APPLICATION FOR PERMIT TO DRILL OR REENTER

2. Name of Operator XTO PERMIAN OPERATING LLC		8. Lease Name and Well No. JRU DI 11 WHITLASH 515H 326113
3a. Address 6401 Holiday Hill Road, Bldg 5 Midland TX 79707	3b. Phone No. (include area code) (432)682-8873	9. API Well No. 30-015-46283

PECOS DISTRICT DRILLING CONDITIONS OF APPROVAL

**PECOS DISTRICT
SURFACE USE
CONDITIONS OF APPROVAL**

Figure 1. Cross-sections and plans for typical road sections representative of BLM resource or FS local and higher-class roads.

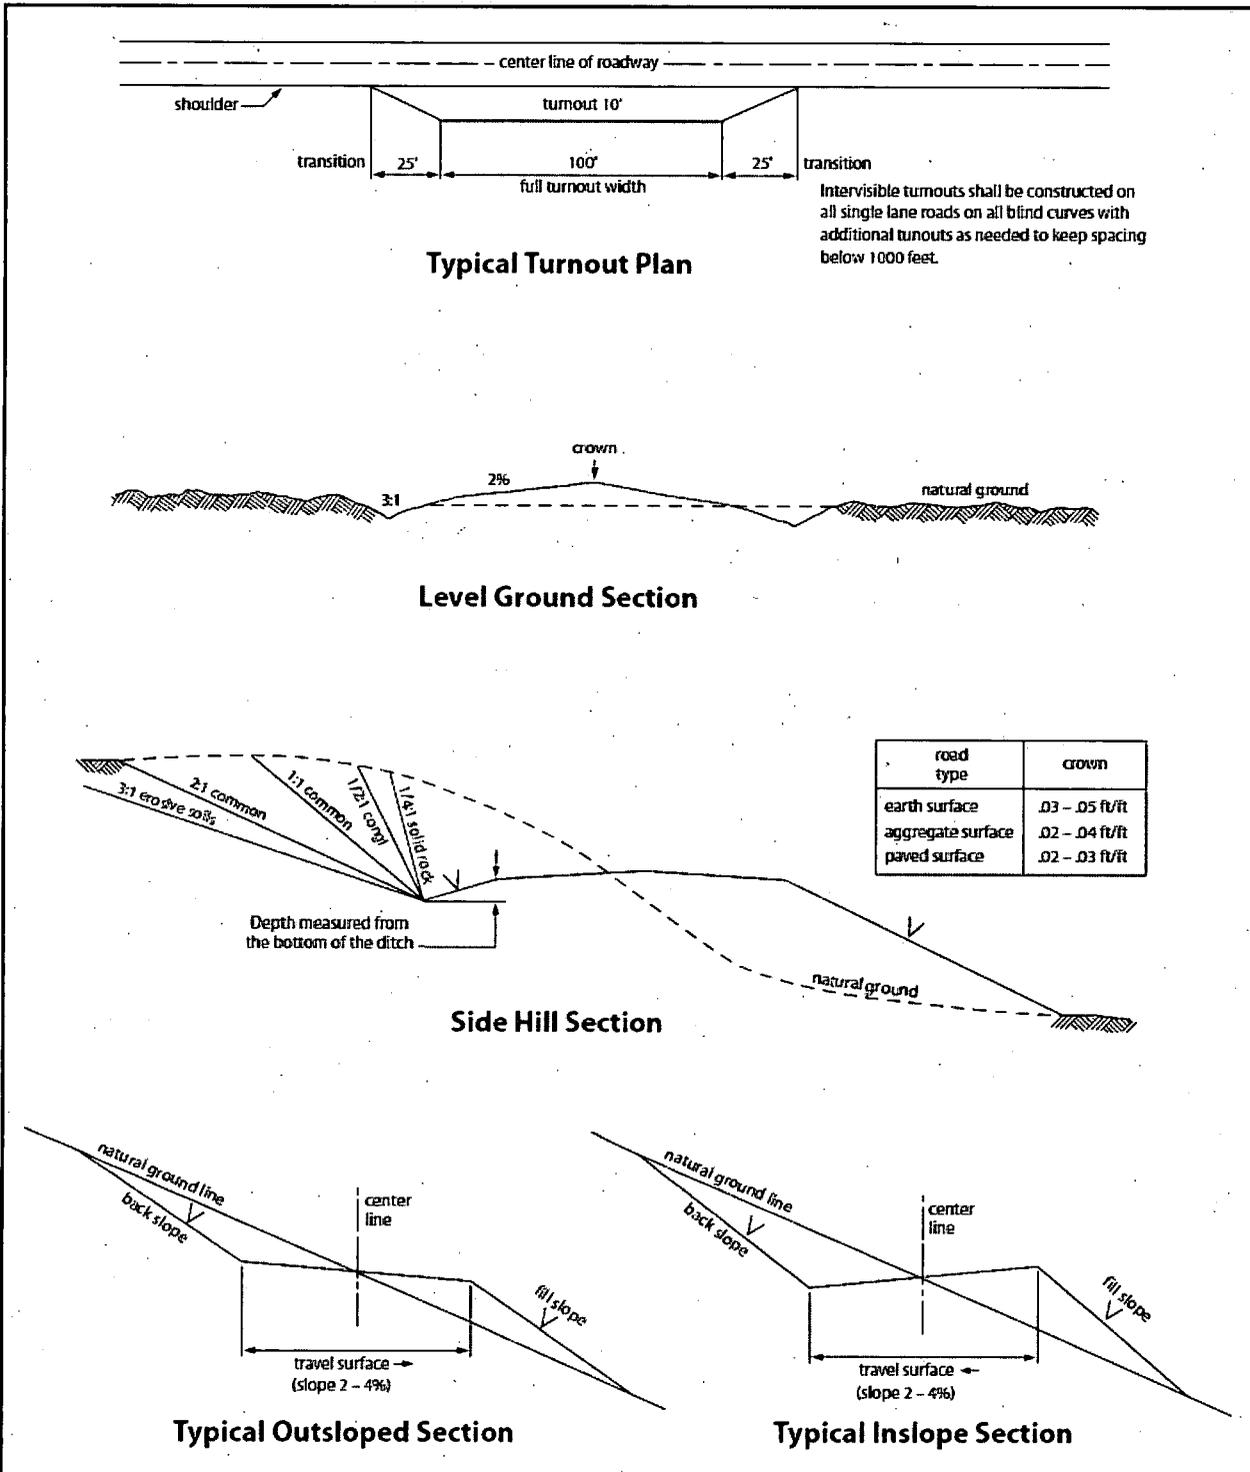
Crowning shall be done on the access road driving surface. The road crown shall have a grade of approximately 2% (i.e., a 1" crown on a 14' wide road). The road shall conform to Figure 1; cross section and plans for typical road construction.

Ditching shall be required on both sides of the road.
